INDIANA DEPARTMENT OF TRANSPORTATION

STANDARDS COMMITTEE MEETING

APPROVED MINUTES

November 20, 2008 Standards Committee Meeting

INDIANA DEPARTMENT OF TRANSPORTATION	
UNDERDRAIN DETAILS	
JANUARY 2000	
STANDARD DRAWING NO. E 718-UNDR-01	
DESIGNED BY No. 18055 DATE 1-02-00	CHECKED BY No. 18055 DATE 1-02-00
DRAWN BY No. 18055 DATE 1-02-00	
CHECKED BY No. 18055 DATE 1-02-00

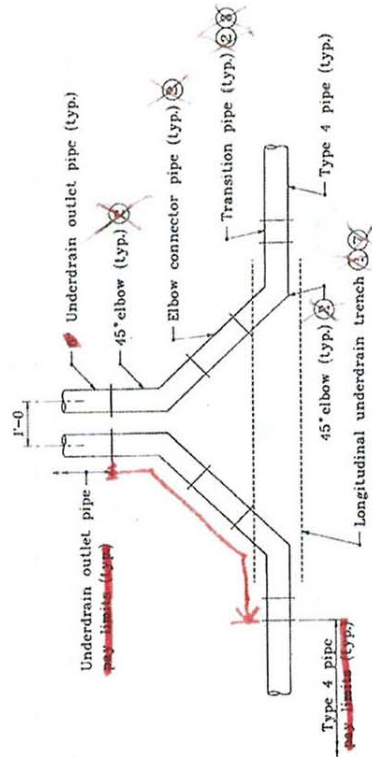
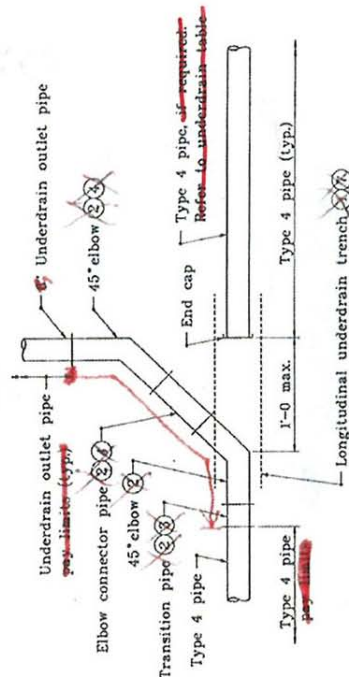
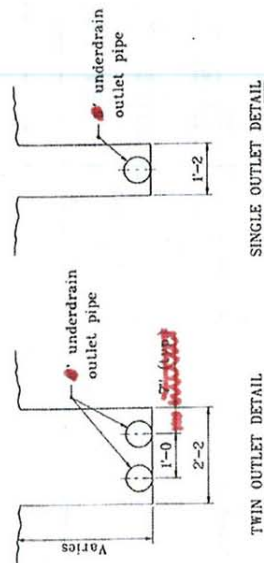
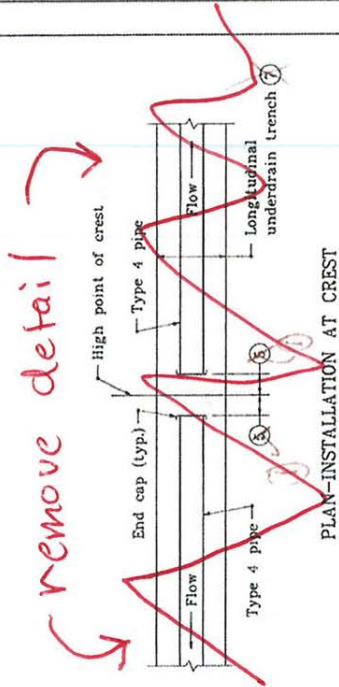
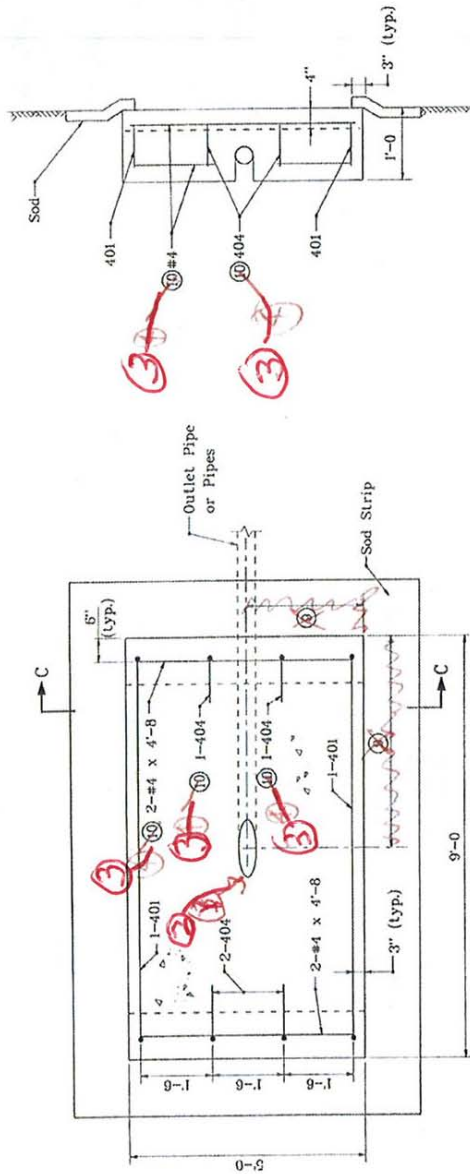
PROBLEM(S) ENCOUNTERED: In February 2008, Pay Limit information was removed from Standard Drawing E 718-UNDR-01 and placed in the Standard Specifications. For consistency, General Notes on E 718-UNDR-07 should be revised to place appropriate information in the Standard Specifications.

PROPOSED SOLUTION: Remove specification related information from General Notes on Standard Drawing E 718-UNDR-07 and place in appropriate part of 718. Revise Standard Drawings E 718-UNDR-01, E 718-UNDR-02, E 718-UNDR-03, E 718-UNDR-04, E 718-UNDR-05 and E 718-UNDR-07 to reflect changes.

1. See Standard Drawing E 718-UNDR-07 for General Notes ~~pertaining to this sheet.~~

INDIANA DEPARTMENT OF TRANSPORTATION
 BRIDGE ELASTOMERIC BEARING PADS
 TYPE S - FOR STEEL BEAMS
 SEPTEMBER 2008
 STANDARD DRAWING NO. E-726-BEBP-03

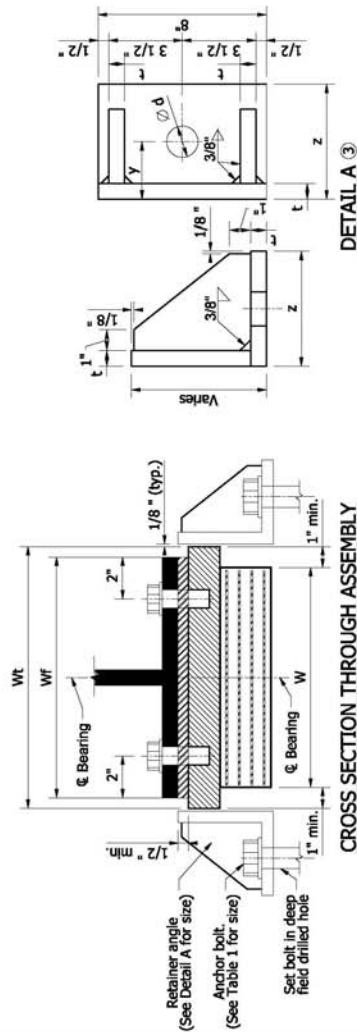
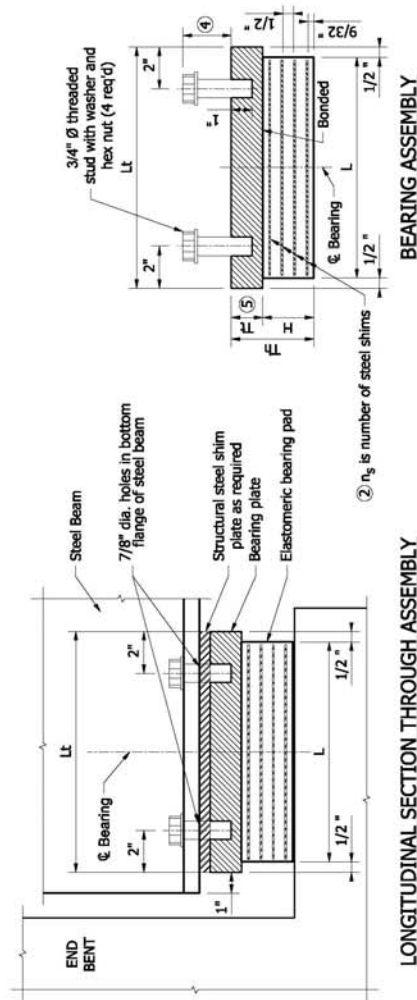
- NOTES:
- The bearing plate size shall be calculated as follows:
 $Lt = L + 1"$ or $Wt = Wf + 2"$ or $Wt = W + 2"$ whichever is greater.
 - The shim thickness is 0.1046 in., which corresponds to 12 gage stainless coils.
 - Equivalent rolled angle shape with stiffeners may be used in lieu of welded plates.
 - Minimum dimension required is $1 \frac{1}{2}"$ + flange thickness + $\frac{1}{3}"$ (for shim plate).
 - Minimum thickness $1 \frac{1}{2}"$
 - See standard drawing E-726-BEBP-04 for Table of Dimensions.
